Rotherhithe to Canary Wharf River Crossing

Value Engineering

Transport for London

04 October 2018

Figure 3: Option 3 - Sheet piles around the proposed piers

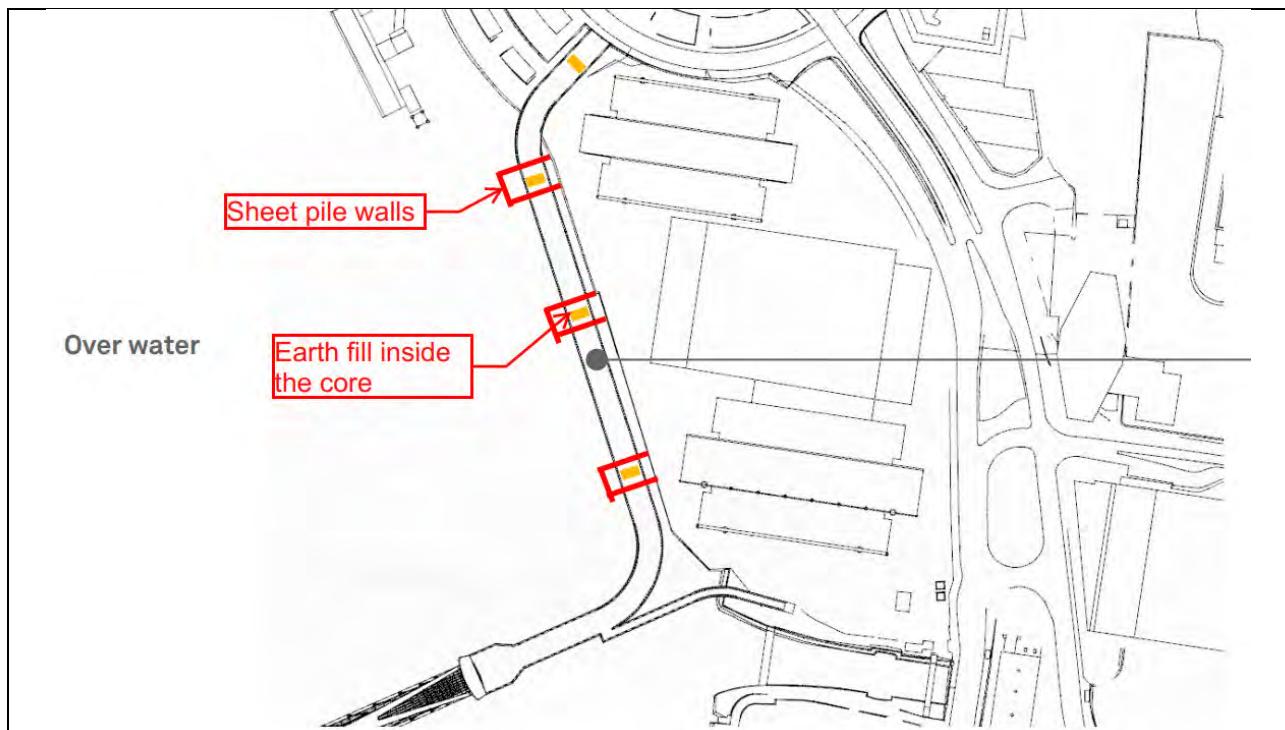
If the EA does not accept the vicinity of the monopiles from the front of the river wall due to their maintenance requirements, option 3 can be considered. Locally replace parts of the existing river wall with a new sheet pile wall that steps out (in plan) towards the river where the piers and foundations are to be located, refer to Figure 3. It is assumed the new river wall will require approximately 120m plan length of AZ46 sheet pile sections that are approximately 20m in length (using the baseline approach ramp foundation design).

Similar to Option 1 – record information on the existing river wall is required to assess whether it can support the piling rig.

Consultation with EA is required to fully understand their maintenance requirements. If the EA maintenance requirements can be avoided, then it would be significantly preferable to pursue Option 2 rather than Option 3.

APPROACH SPANS ORIGINAL DECK WIDTH - 8.1m

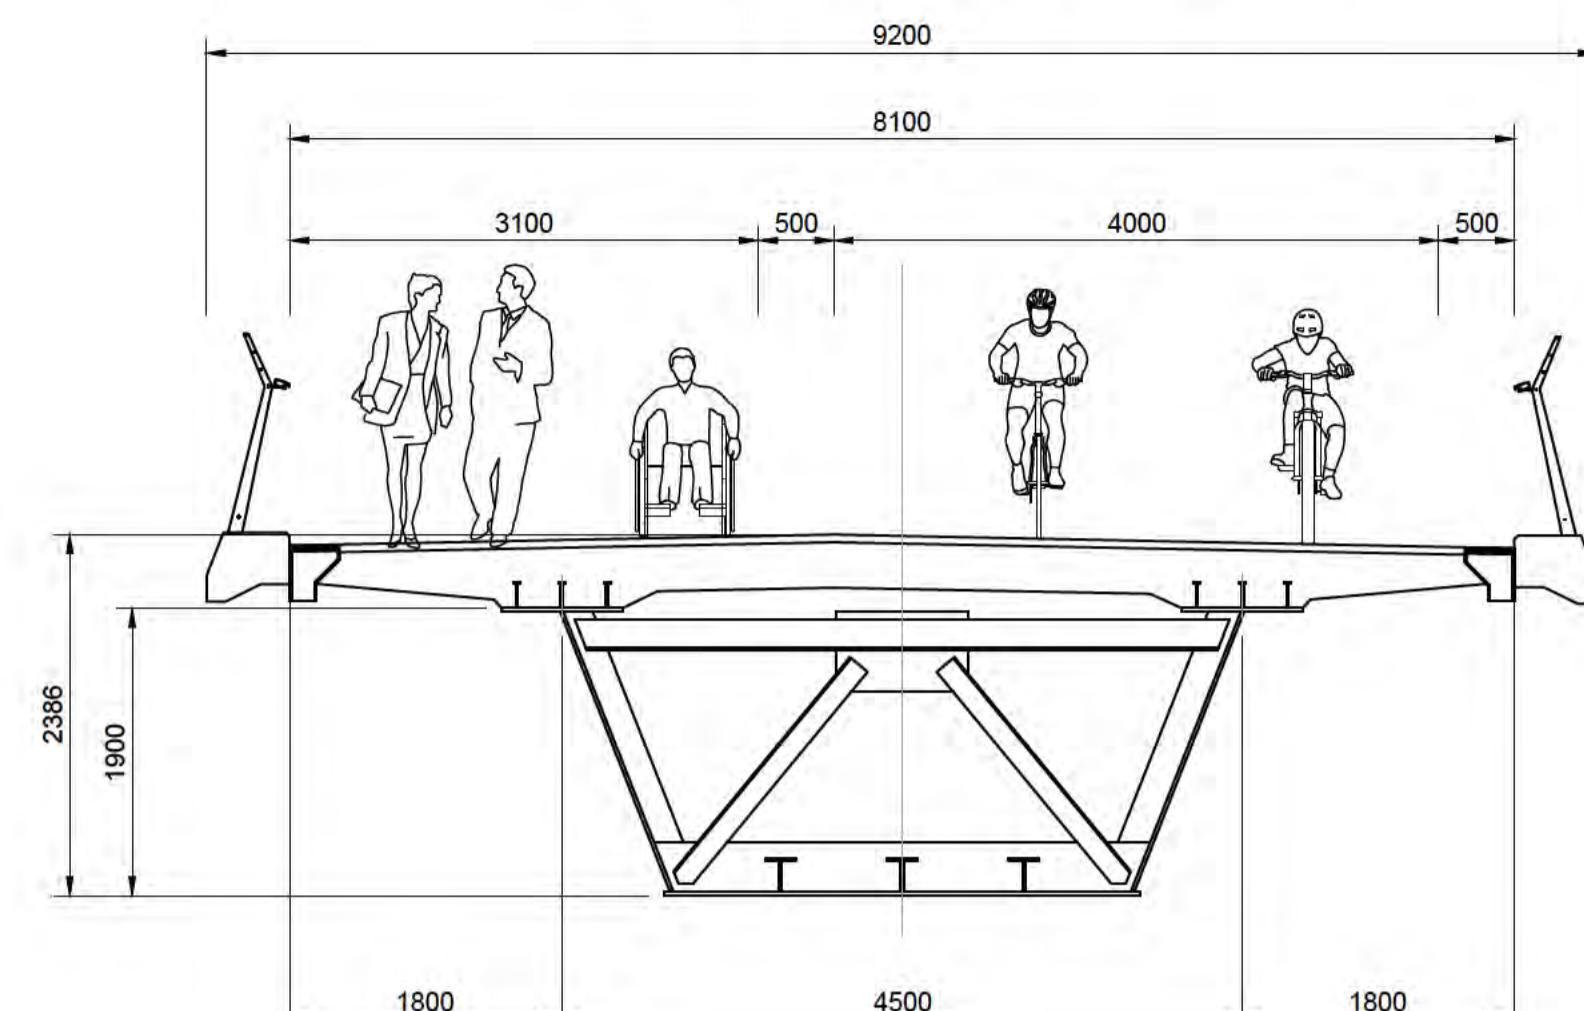
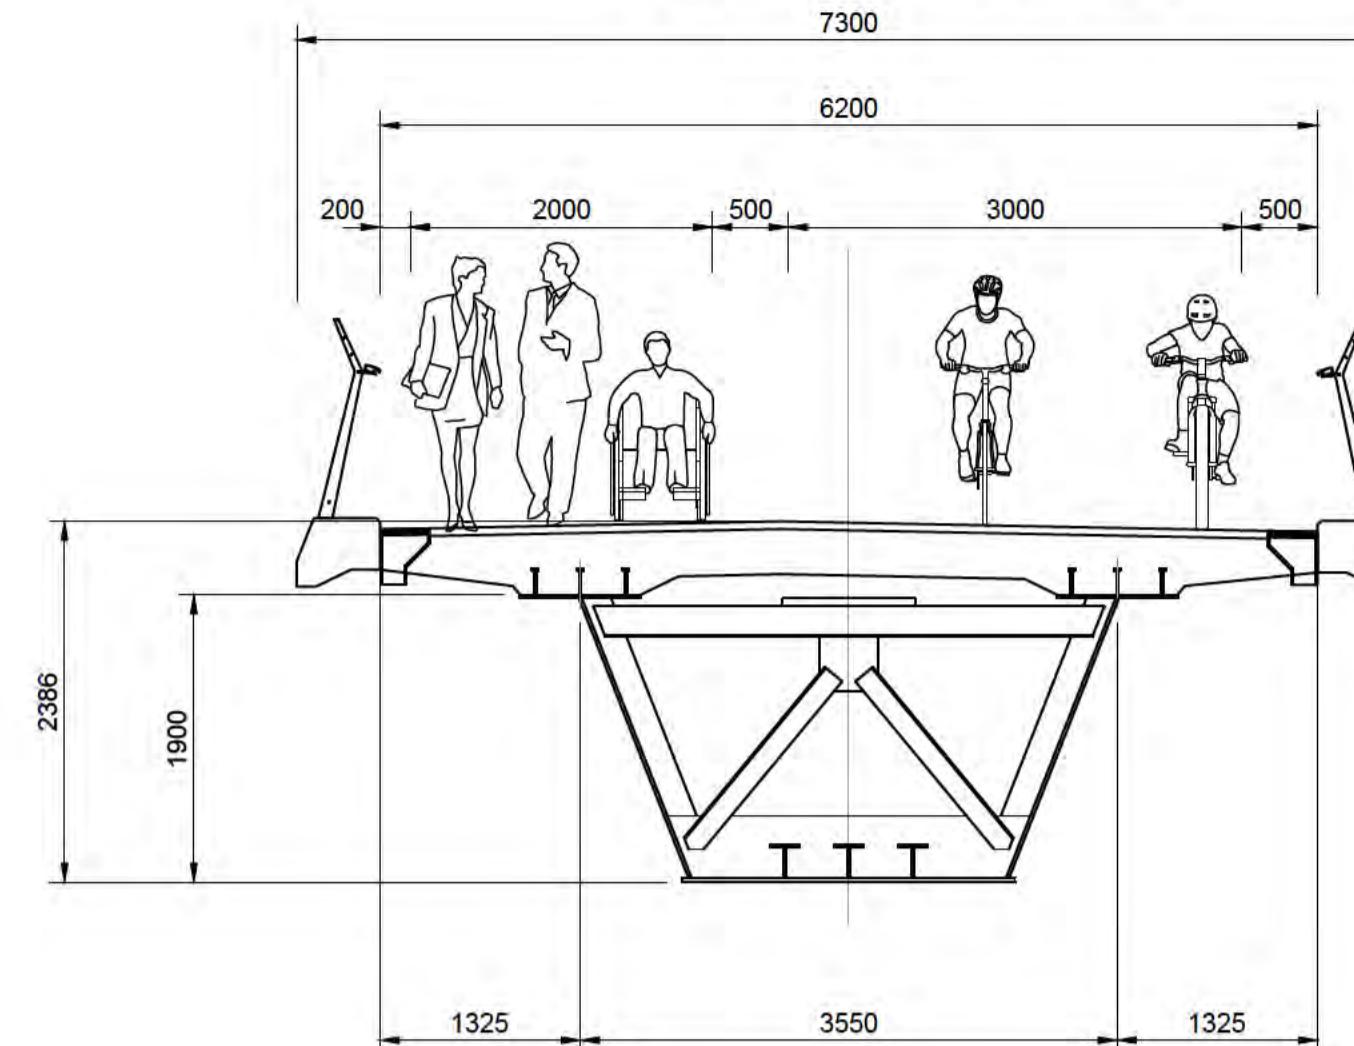
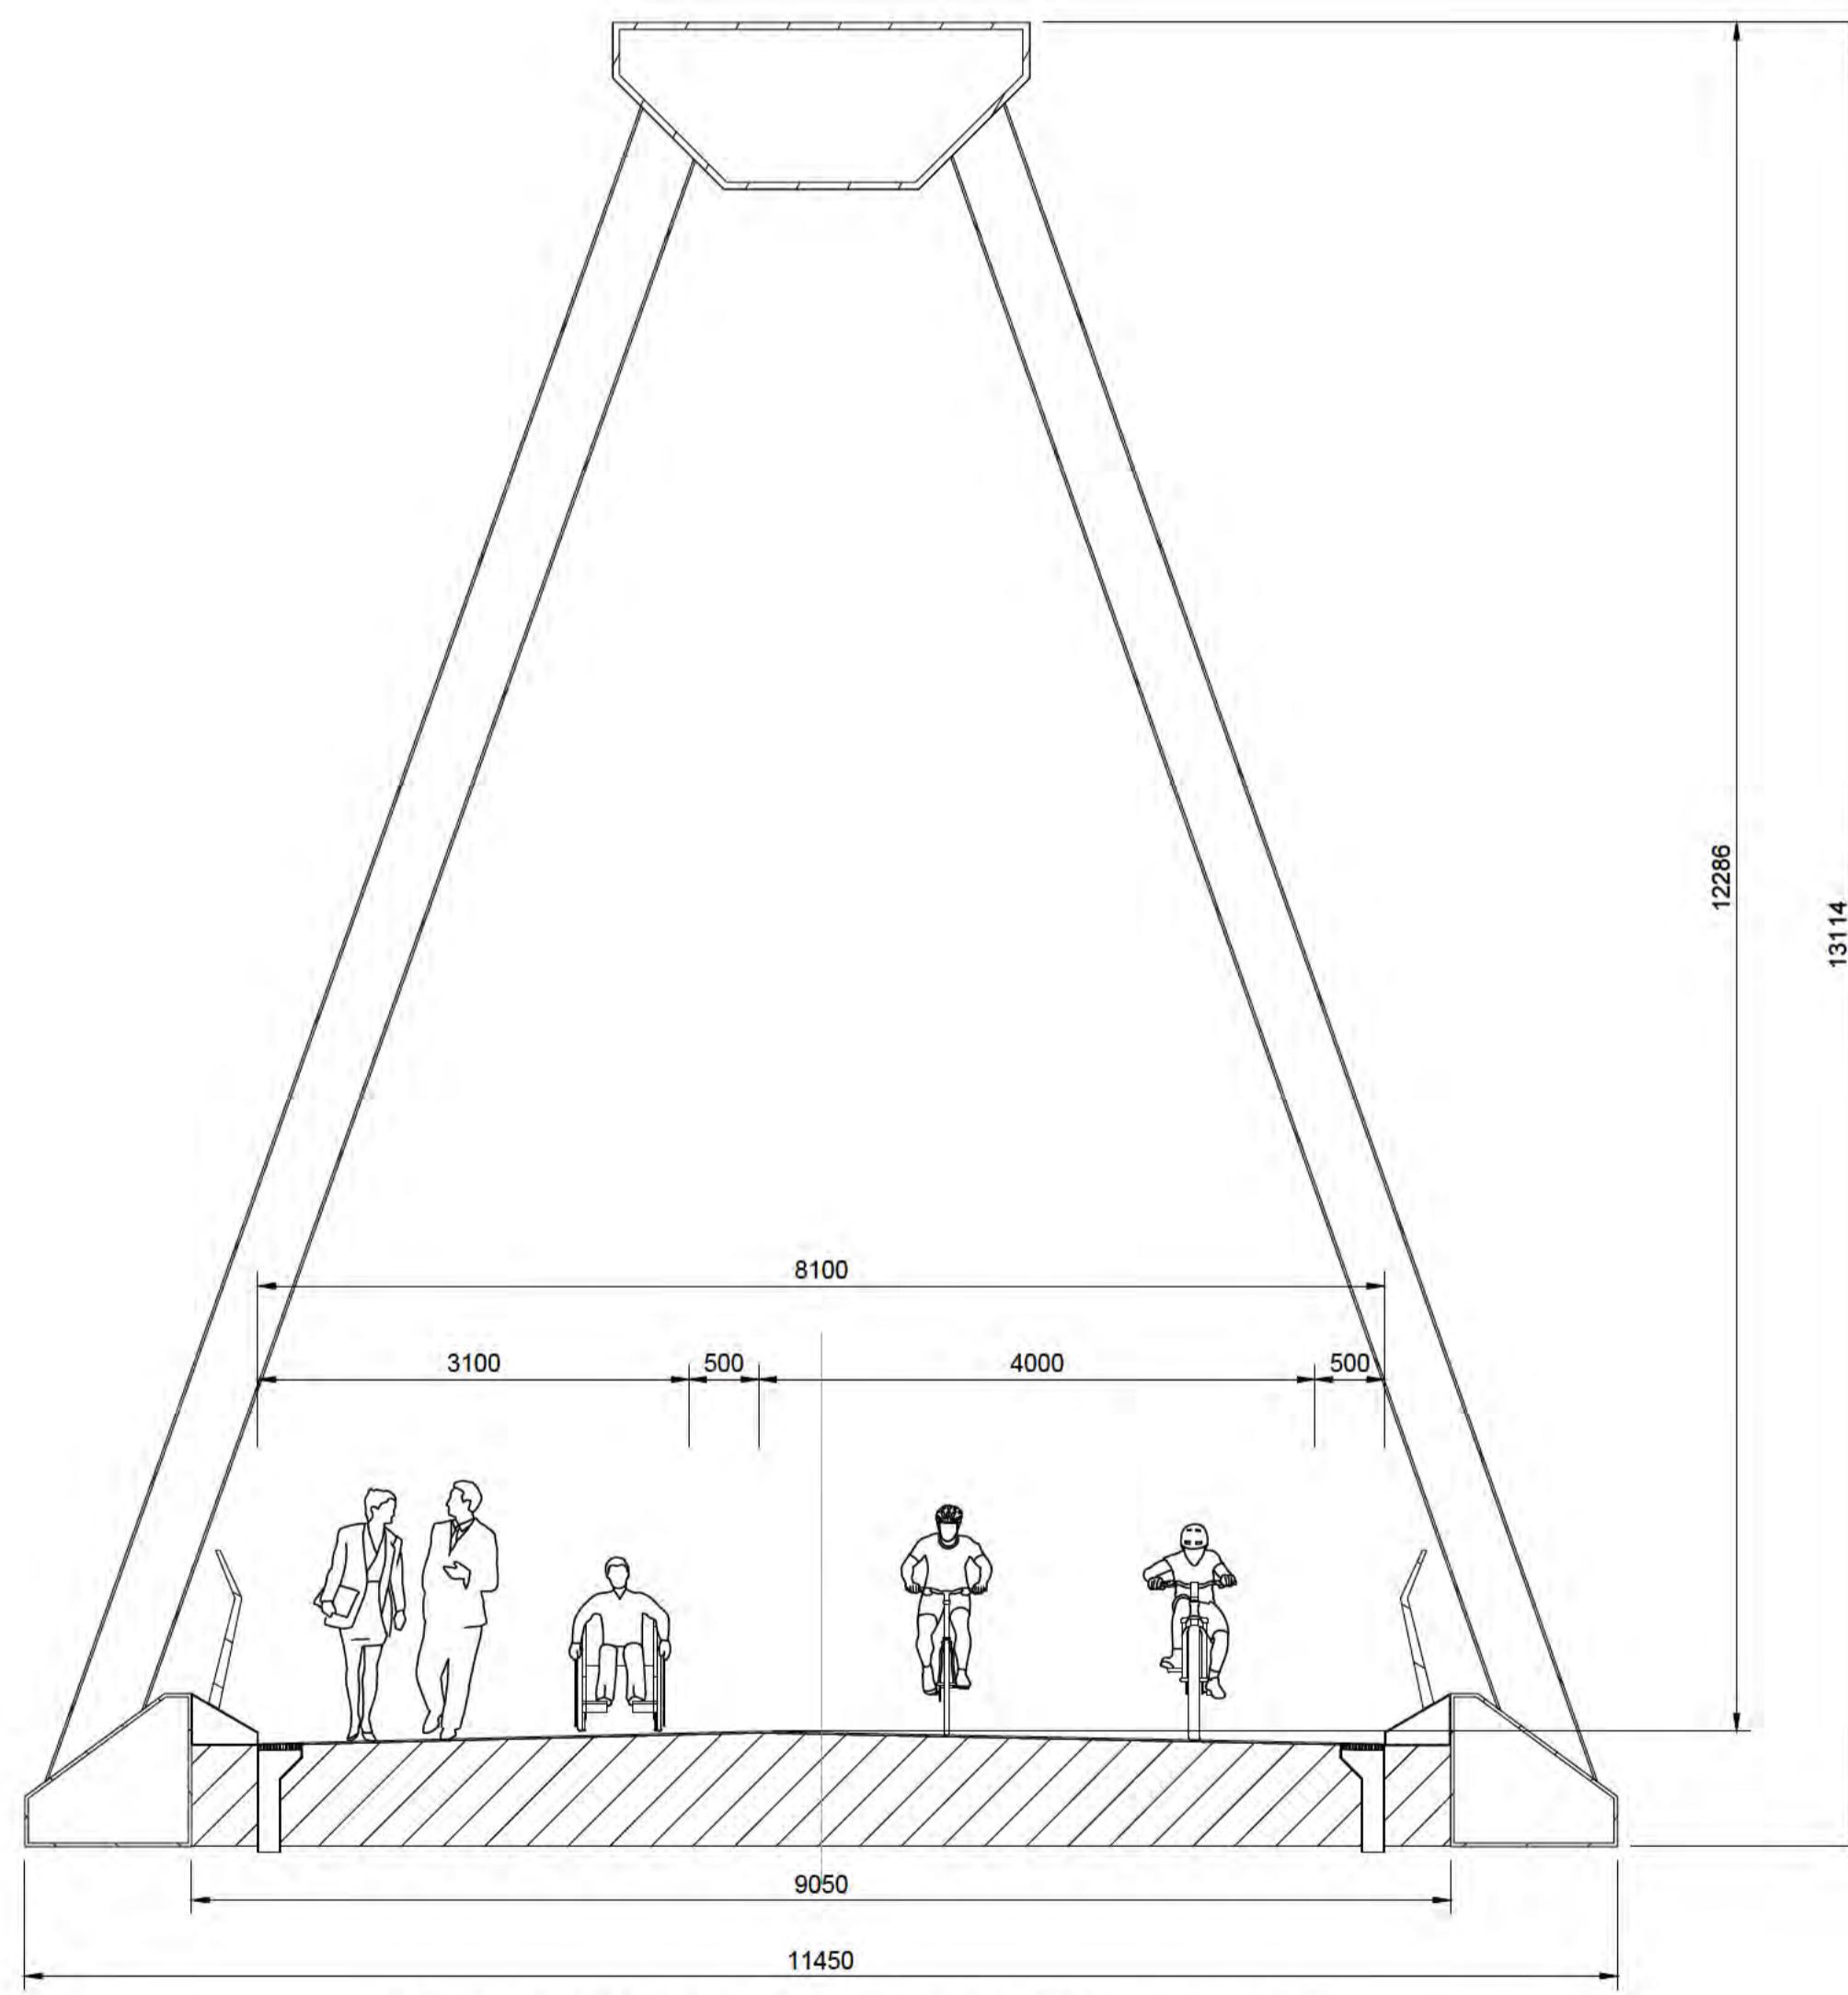
The VE03 proposes minimum acceptable clear width of the deck as 6.20m (=2.00+3.00+0.20+0.50+0.50 & total deck width = 7.3m). Refer Figure 1 for details. The comparison of the min. deck width with the original deck width is presented in sketch ST_PJ585C-ATK-BAS-ZZ_21-DIA-ST-00002.

Option 1:

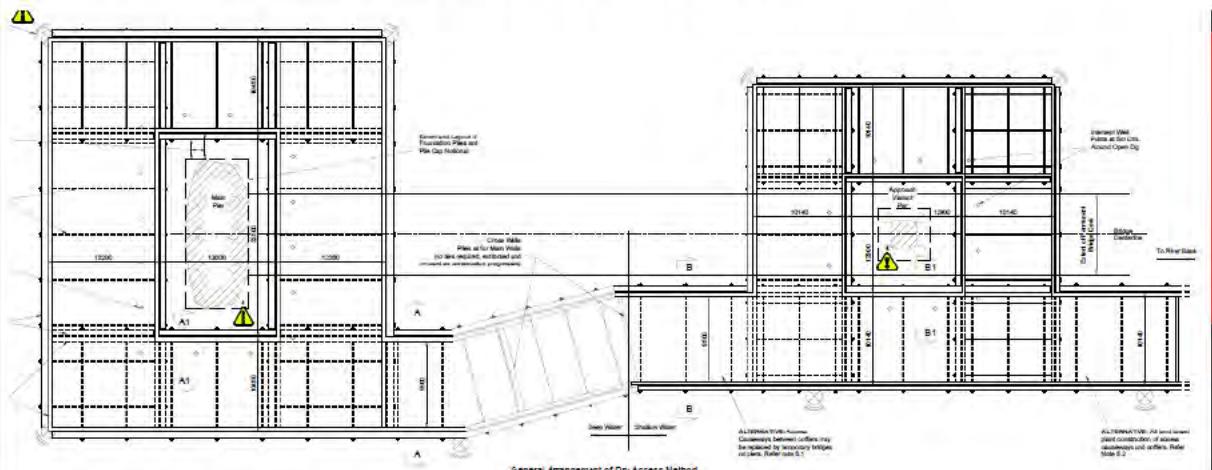
Heavy duty, solid structure – extended double walled cofferdam (9-12m wide) infilled with ballast to link pier workfaces. This will require significant sheet piling with a Giken rig or similar. This will then require structural backfilling to enable heavy plant and equipment to traverse.

Significant additional works and costs required to fabricate and construct which may counter the savings made by removing marine plant requirements.

Large quantity of sheet piles to be sourced.

Image from Thames Cable Car

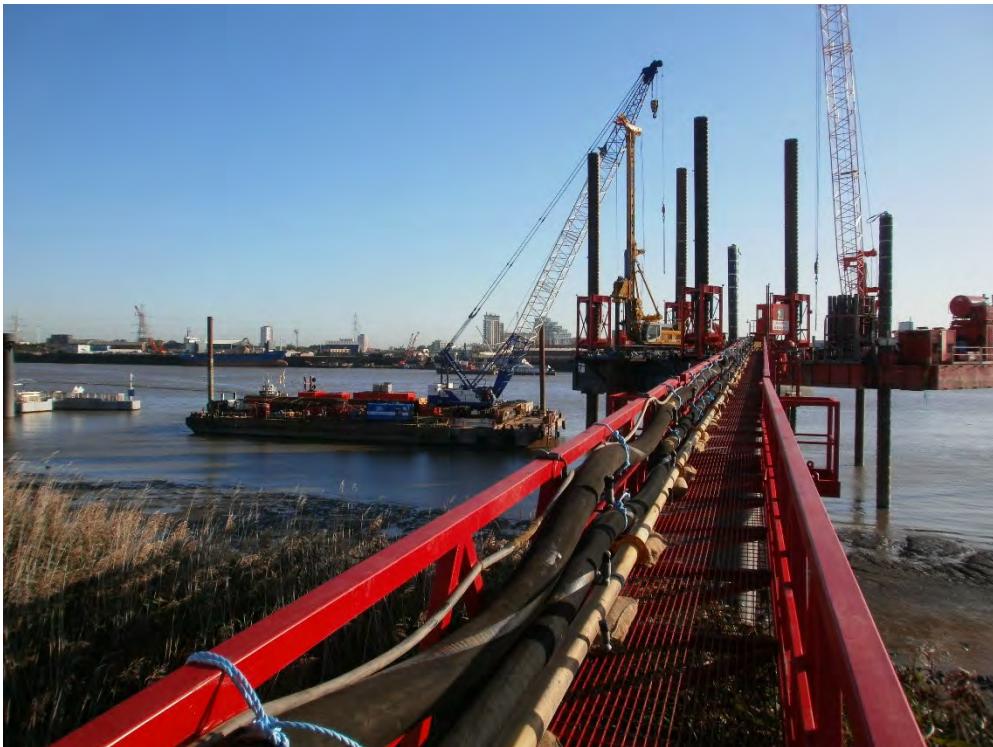
Simply supported bridge sections spanning between adjacent pier construction worksites to provide operative access and to carry pumping lines for concrete. Temporary intermediate supports would be required between the permanent piers.

Figure 1 Clear span of the key bridges on the River Thames

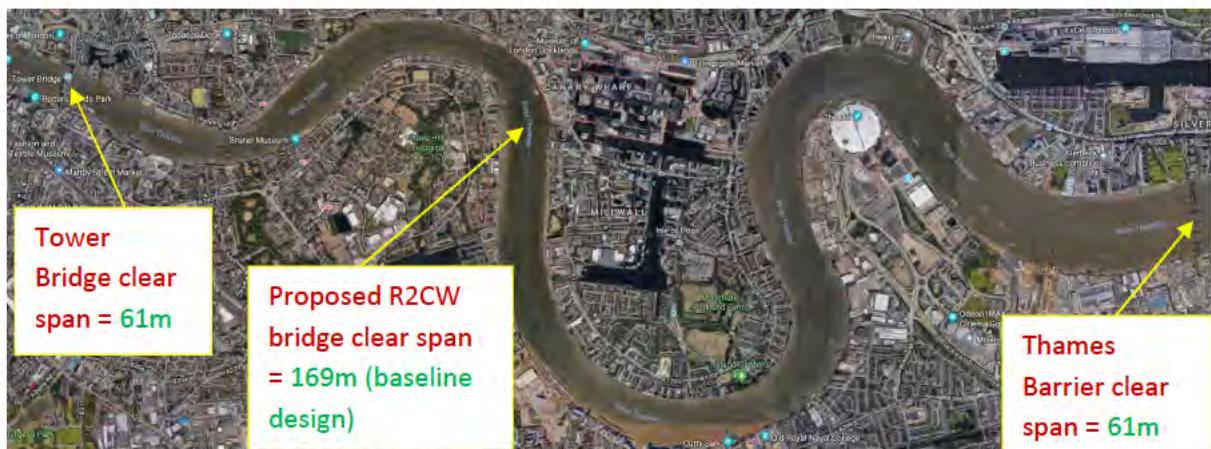
The clear span (or navigable width) of the other significant structures on the River Thames for reference are:

- Thames Barrier – 61m
- Tower Bridge – 61m
